Rezoning Transportation Analysis

Petition Number: 2023-088

Revision Log:	Date	Description
	07-26-23	First Review (PM)

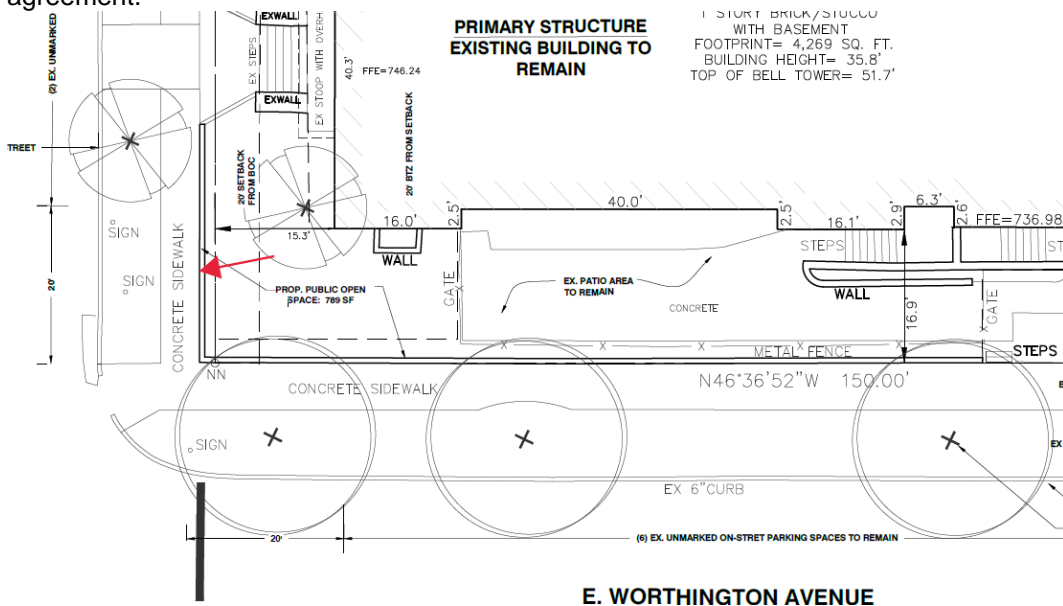
1. Curblines:

- a. **Cleveland Avenue:** The future location of curb and gutter is to be located at 20.5ft per CLDM U-05 series for local commercial wide street typical section.
- b. **Worthington Avenue:** The future location of curb and gutter is to be located at 20.5ft per CLDM U-05 series for local commercial wide street typical section.

NOTE: Additional distance from center line to back of curb may be required in locations where a median is present or around intersections and interchanges.

Label and dimension the future back of curb location from the centerline for each road on the site plan.
